ALERT SERVICE BULLETIN

430-22-61

MODEL AFFECTED: 430

SUBJECT: MAIN ROTOR PITCH LINK ASSEMBLY
COMPONENTS - INSPECTION AND
AIRWORTHINESS LIFE REVISION OF

Figure 1 – Main Rotor Pitch Link Assembly Clevis 10X Inspection Area.

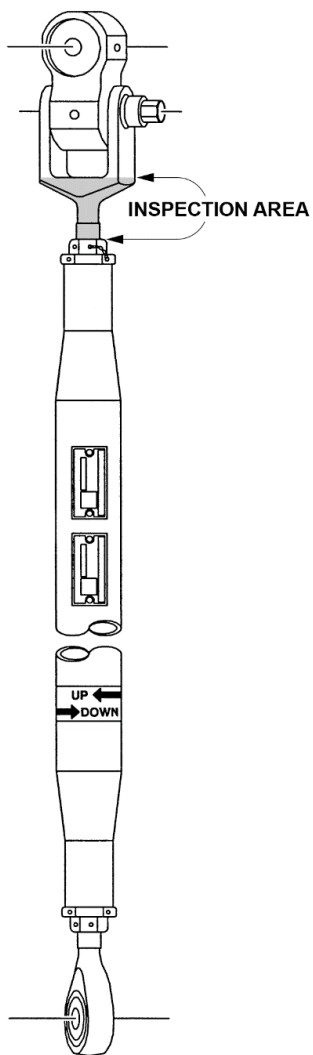
3. Perform a detailed visual inspection of the neck and threaded area of the installed pitch link clevises using a 10X magnifying glass (Figure 1). Inspect for corrosion and mechanical damage (BHT-430-CR&O, Chapter 62).
 - a. If no cracks are found, go to step 5.
 - b. If cracks are found, replace the pitch link clevis (BHT-430-CR&O, Chapter 62).
4. Replace any clevises that are beyond allowable damage limits (BHT-430-CR&O, Chapter 62) and report findings to Bell Product Support Engineering at productsupport@bellflight.com.
5. Make an entry in the helicopter logbook and historical service records indicating findings and compliance with **PART II** of this Alert Service Bulletin.

Figure 1 – Magnetic Particle Inspection (MPI)

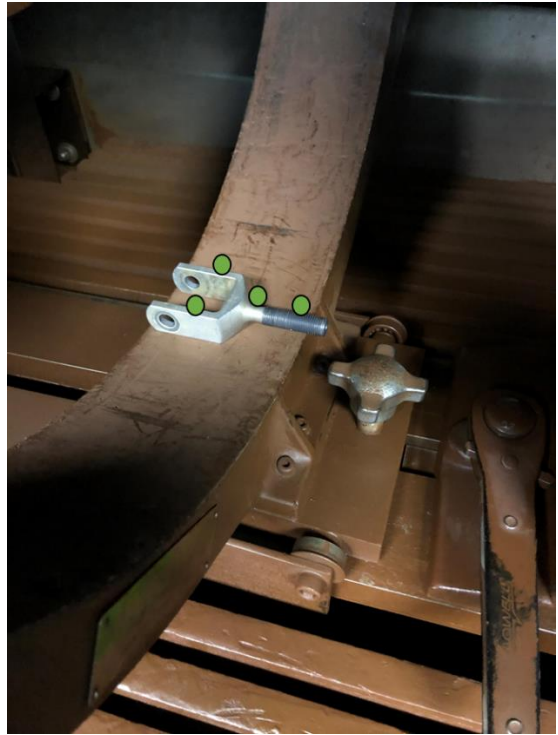
- c. Perform a Magnetic Particle Inspection (MPI) of the clevises as shown in Figures 2 and 3. Perform a demagnetization between Shot #1 and Shot #2, and again upon completion of the inspection. Refer to BHT-ALL-SPM, Chapter 6, for additional information about the magnetic particle inspection procedures.

Shot #1	Shot #2
Central bar through clevis holes	Coil shot, bottom of 5-turn coil
600 Amps – Demagnetize before Shot #2	400 Amps

Figure 2 – Magnetic Particle Inspection (MPI).

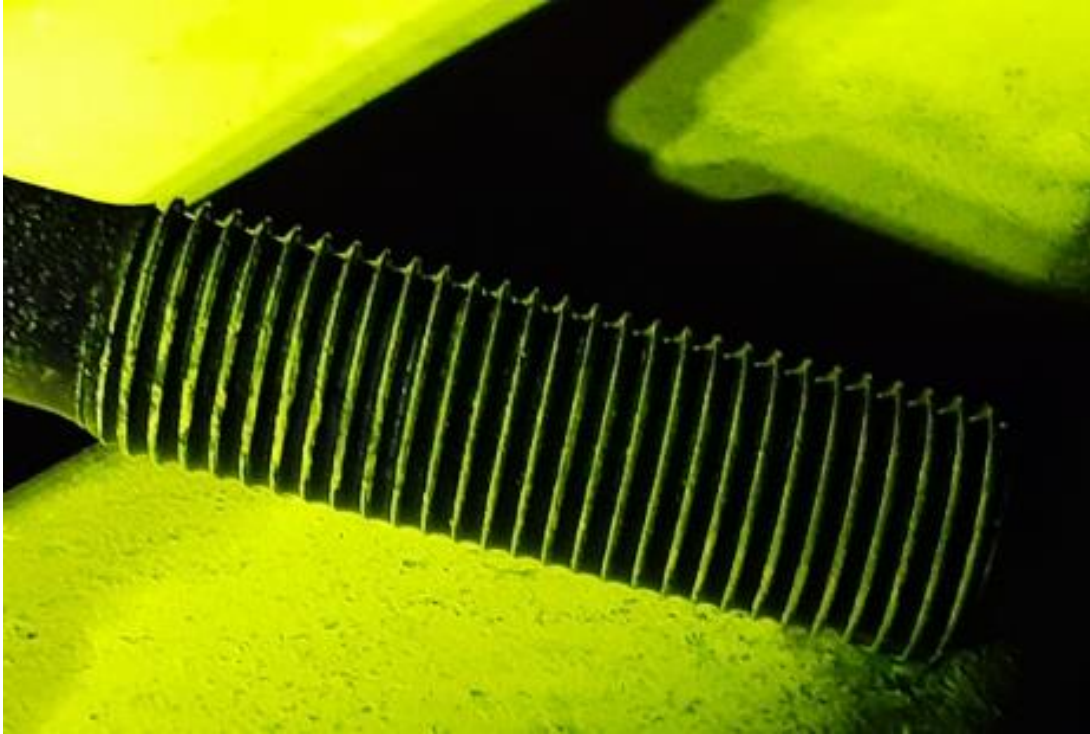
- d. Use a 10X magnifying glass under ultraviolet (UV) lighting to inspect the neck and thread root areas. When inspecting threads, only check the root areas after Shot #2. Top of threads may have fluorescence. If excessive fluorescence is observed on the threads that have been in contact with the coil, rotate the part 180 degrees and perform Shot #2 again.

1. Top of threads may show fluorescence. Inspect root areas for indication of cracking.
2. Due to the fine threads on the clevis, it is recommended that the inspection of the root areas be accomplished using a 10X magnifying glass under UV lighting.
